THE ROYAL GOLF CLUB AT LAKE ELMO

CLUBHOUSE ADDITION

Re: Sketch Plan Review – Royal Clubhouse Expansion

TO: SOPHIA JENSEN
FROM: SARAH EVENSON, PLA
RE: ROYAL GOLF PICKLEBALL AND CLUBHOUSE ADDITION LANDSCAPE AND TREE PRESERVATION PLAN REVIEW MEMO

SITE, UTILITY & GRADING & EROSION CONTROL PLAN

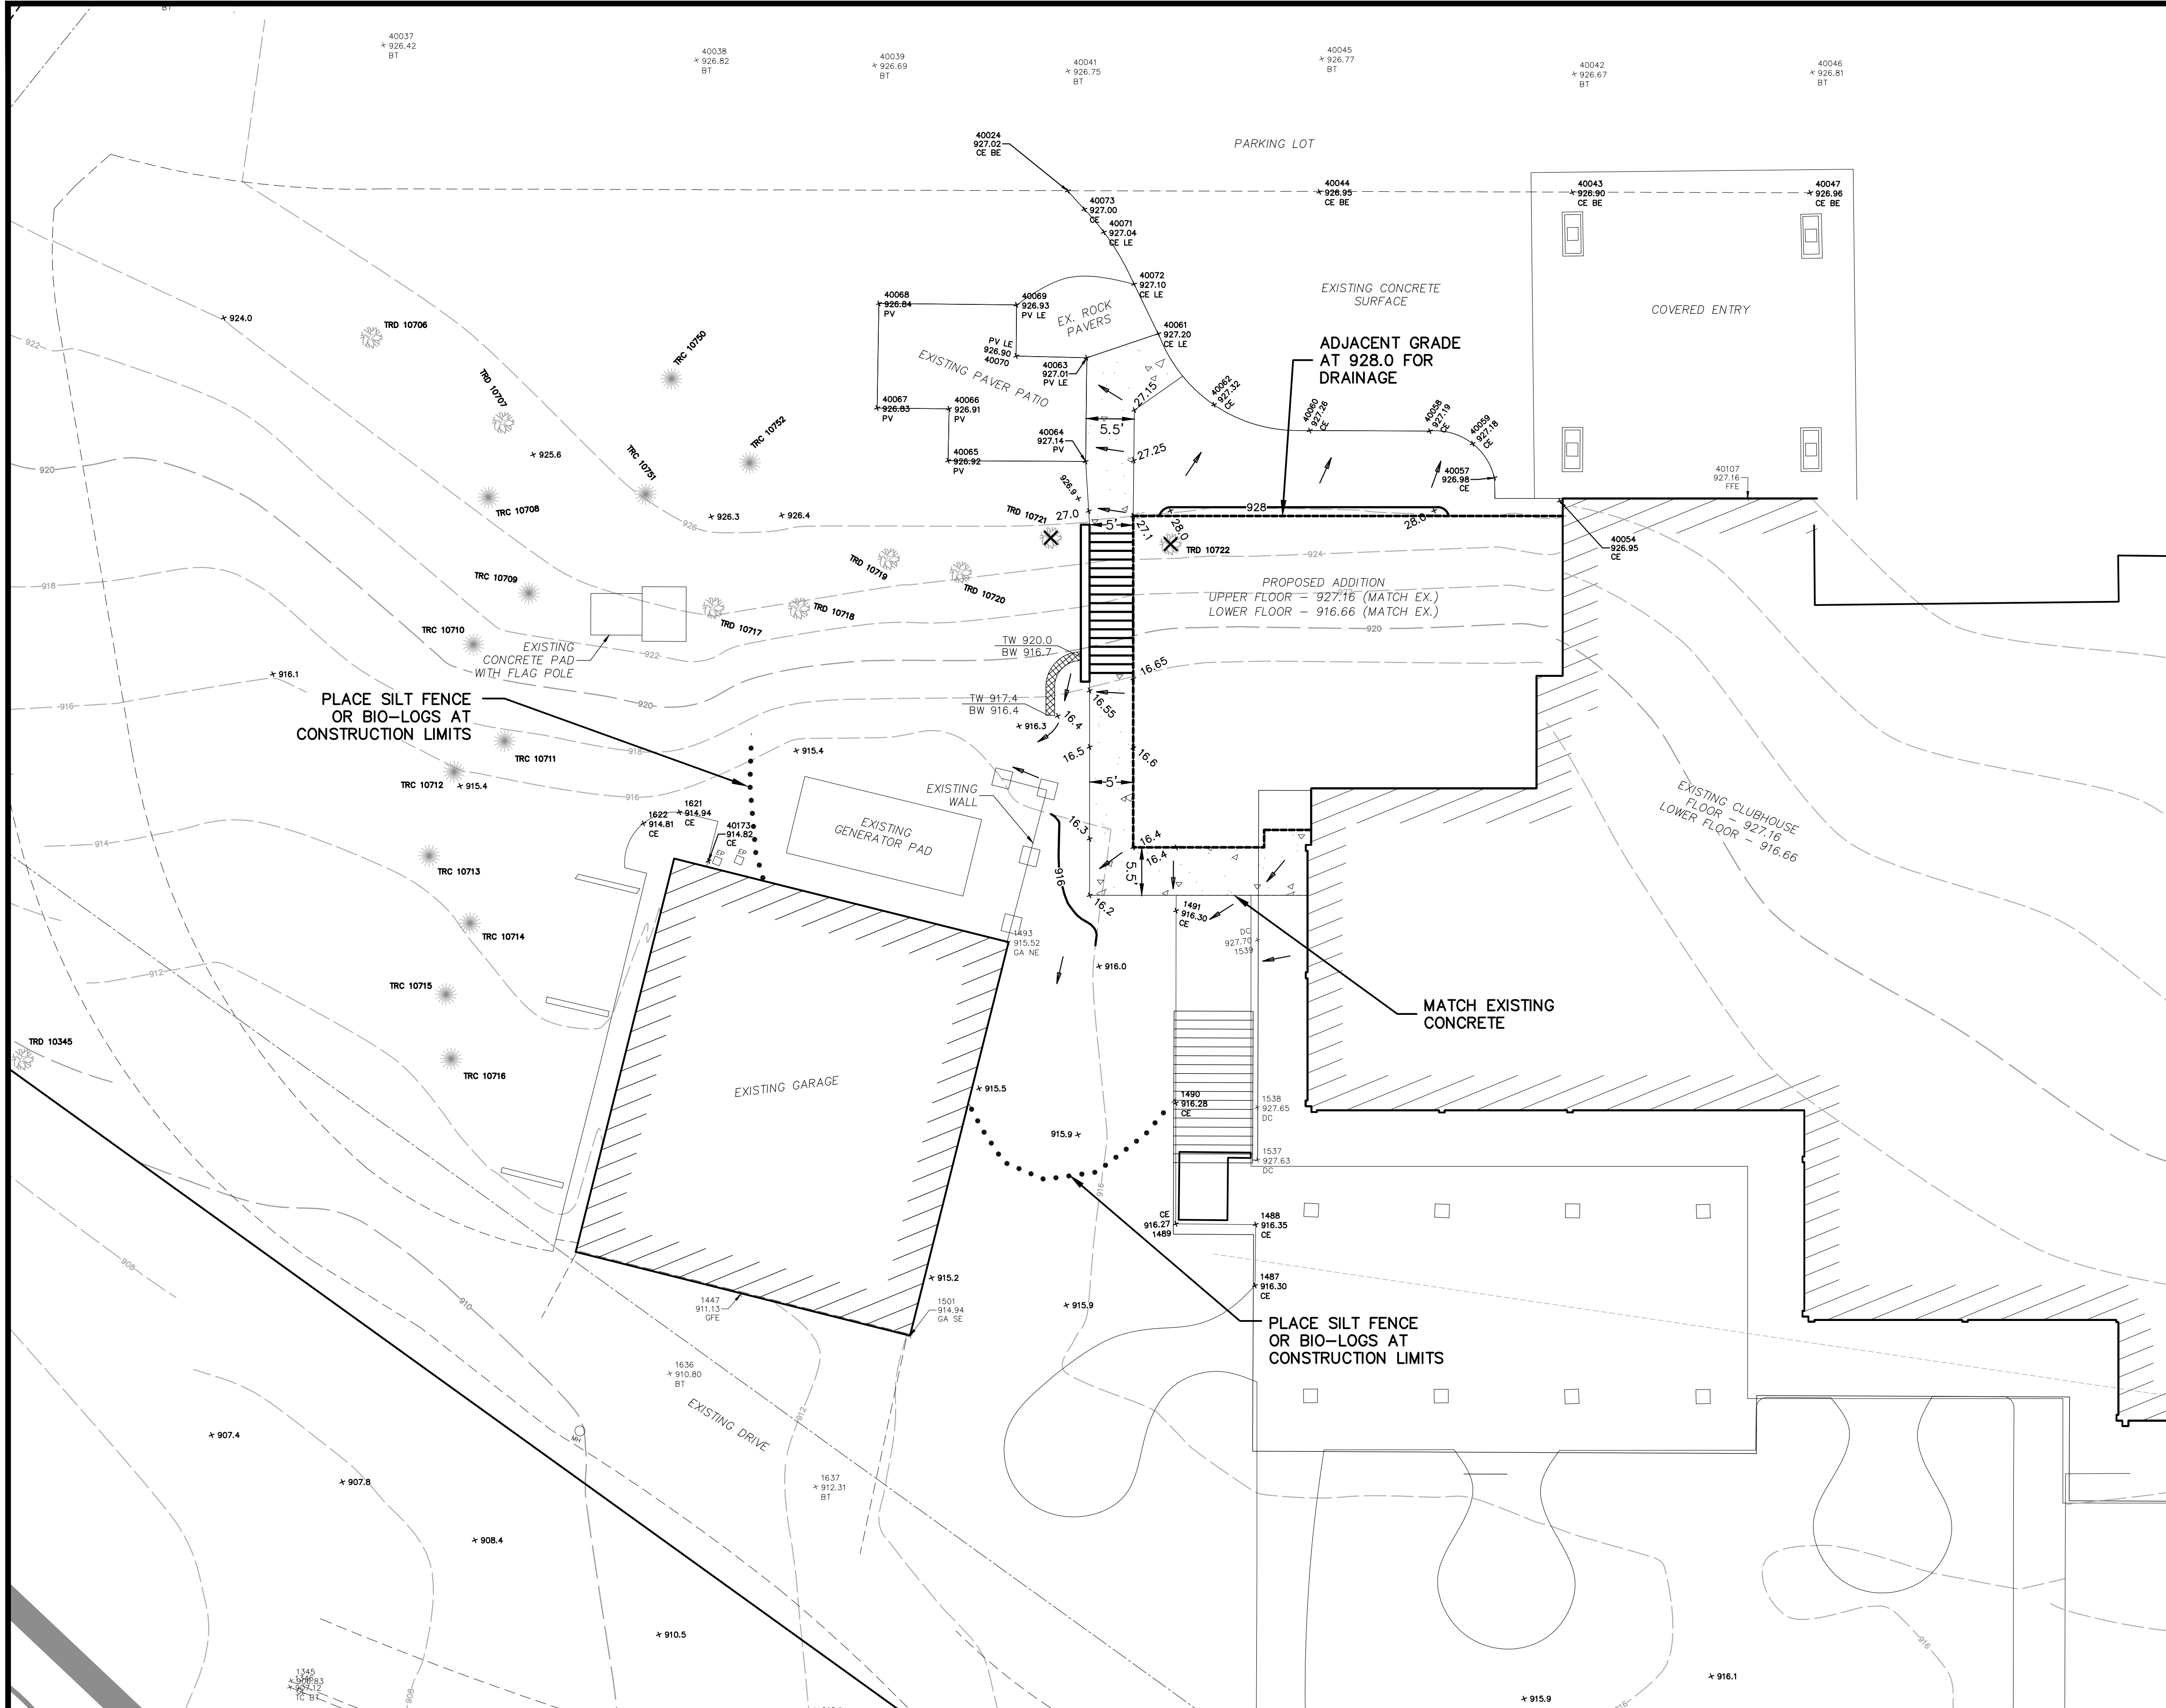
1. No public improvements are proposed or appear to be impacted by the Addition. However the improvements are proposed immediately adjacent to a City owned and maintained watermain. The plans should be revised to clearly show the limits of the watermain easement (easement line labeled and dimensioned on the plans).
2. A plan note should be added to the plans to prohibit any field changes that would result in an easement encroachment.
3. No stormwater management permit is required by the City as the new impervious surface is less than 43,560 SF. However, the VBWD threshold for requiring a permit is only 6,000 SF. The new impervious surface for both the Clubhouse Addition and the Pickleball Court is 6,162 SF. The applicant should be directed to consult with the VBWD to determine if a permit is needed.
4. Please let me know if there is any further review requested at this time.

OVERALL SITE

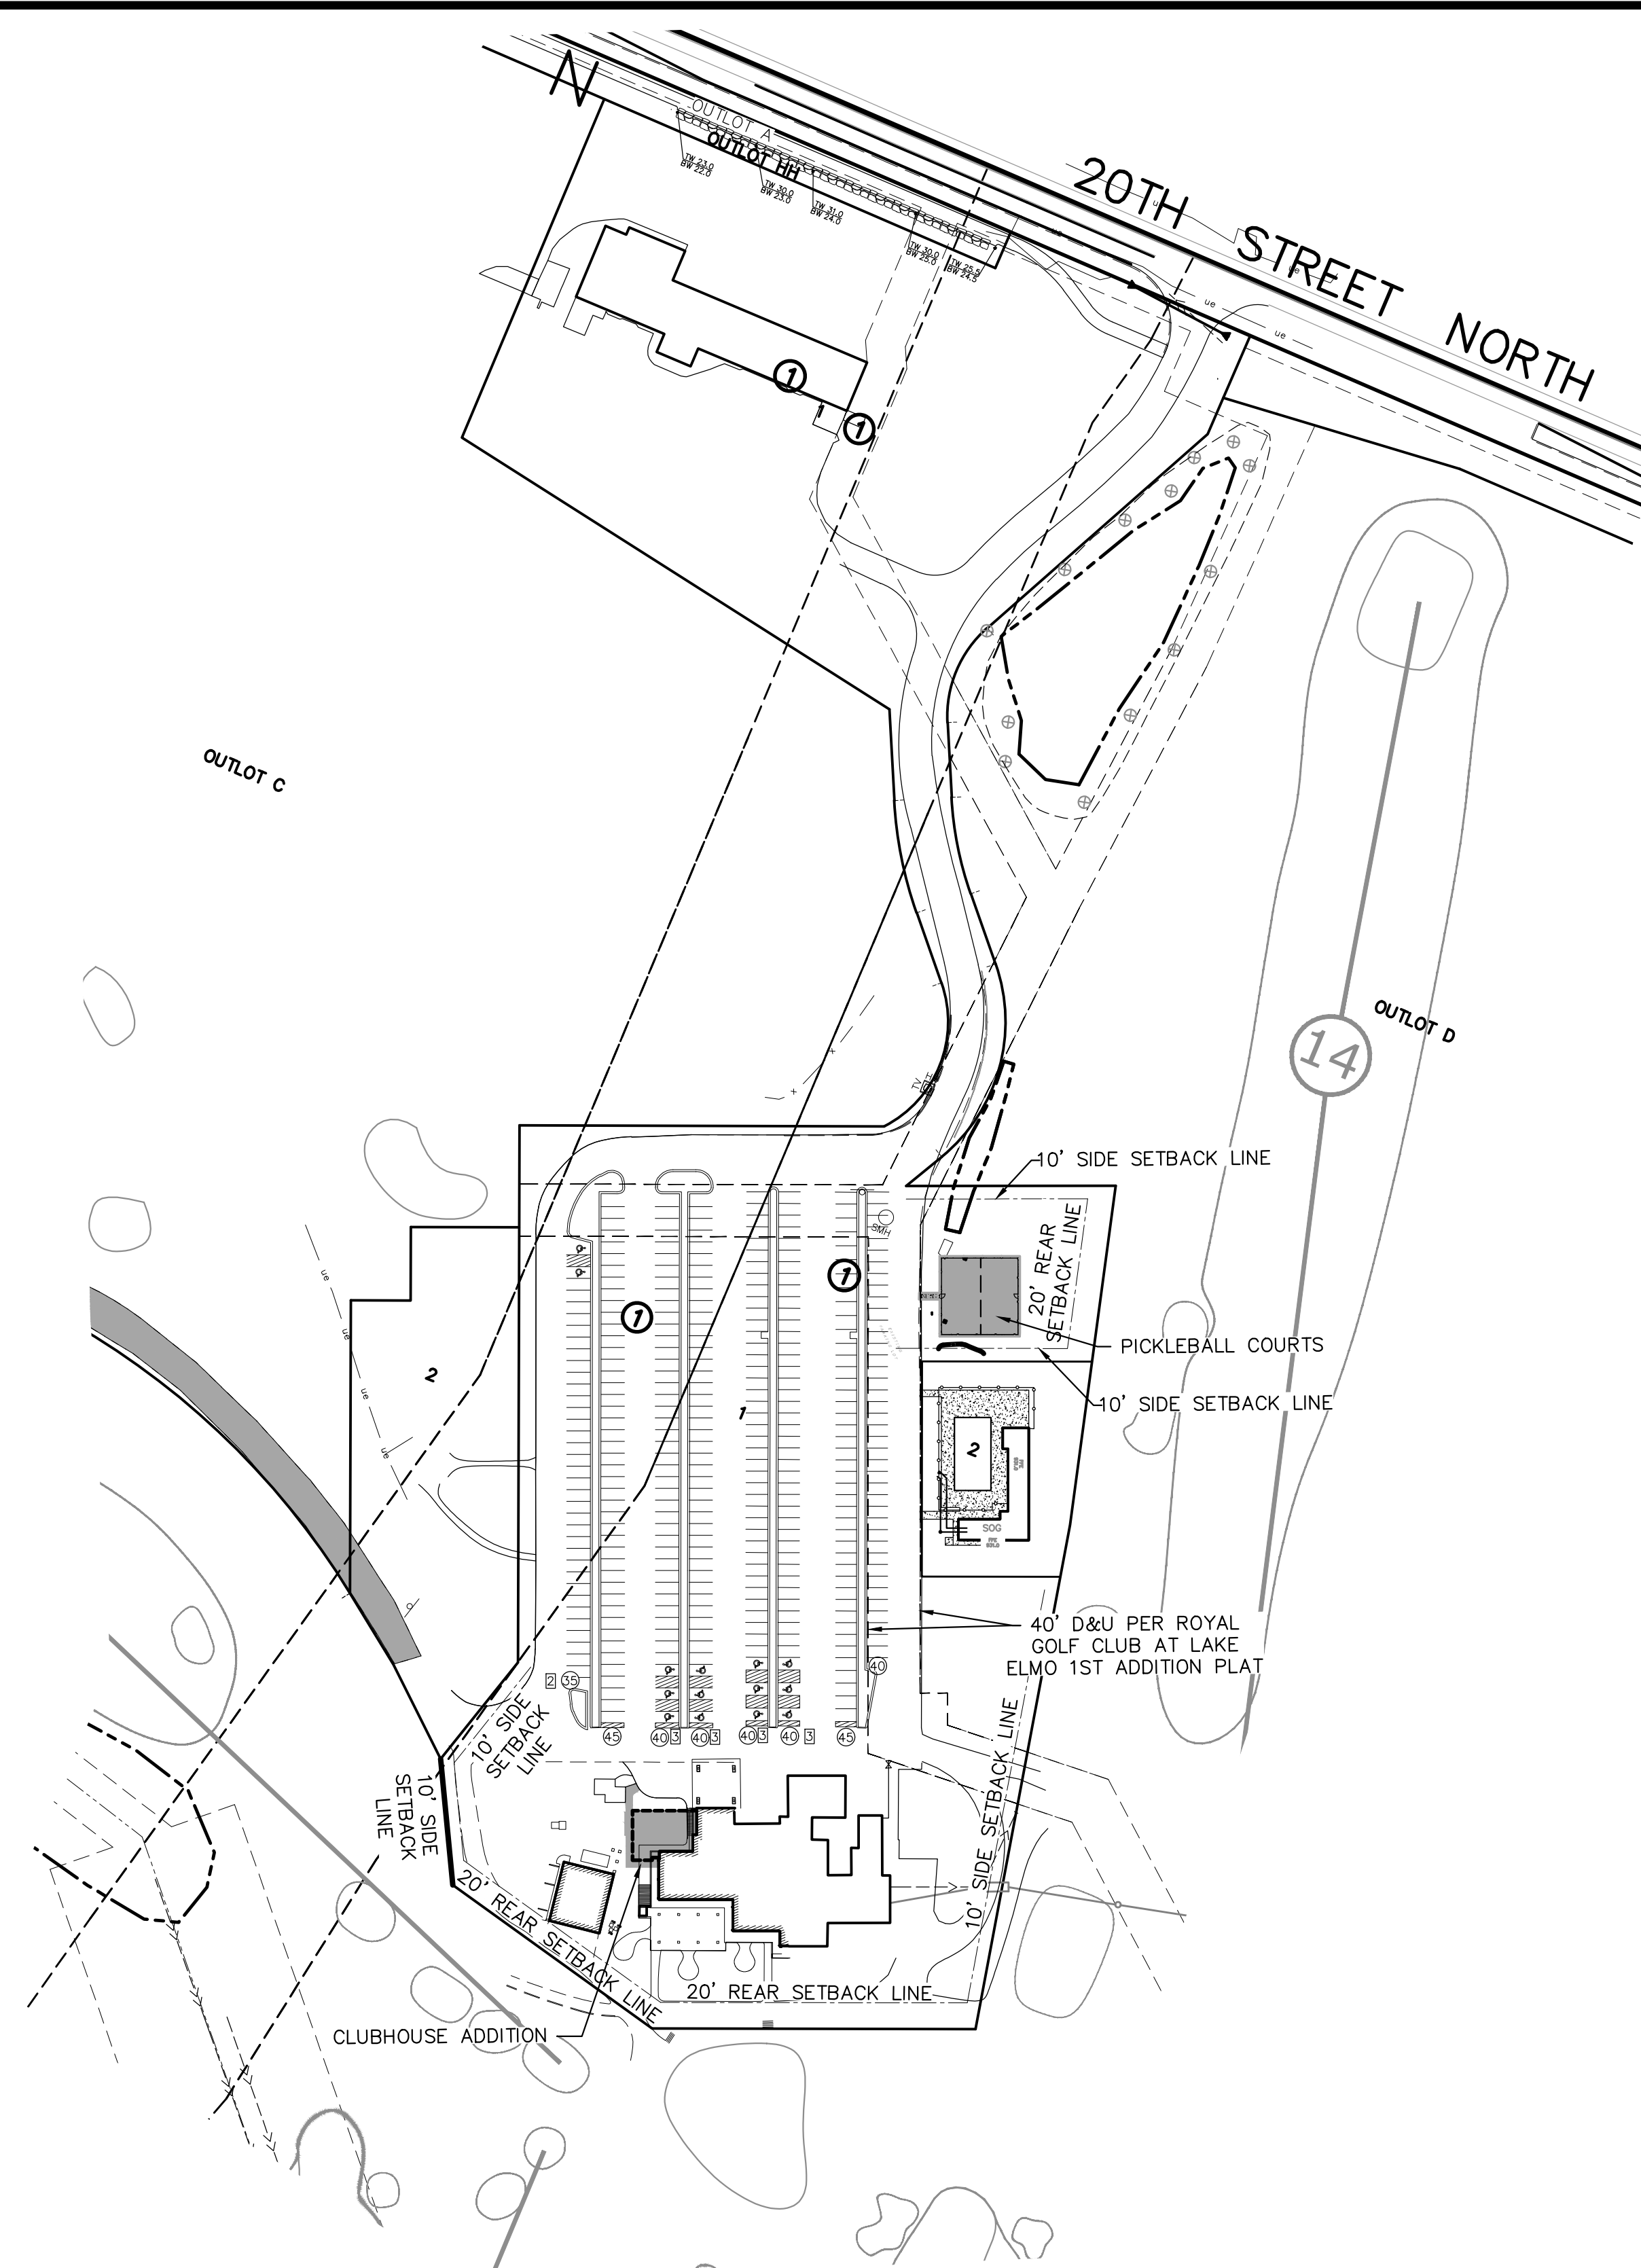
I received the attached updated plans from Justin Olson of Carlson McCain. By reducing the pickleball courts by 0.75-feet off all sides of the court, we are now below the 6,000 square feet permit trigger for VBWD.

Thank you. No permit is needed from the Valley Branch Watershed District.
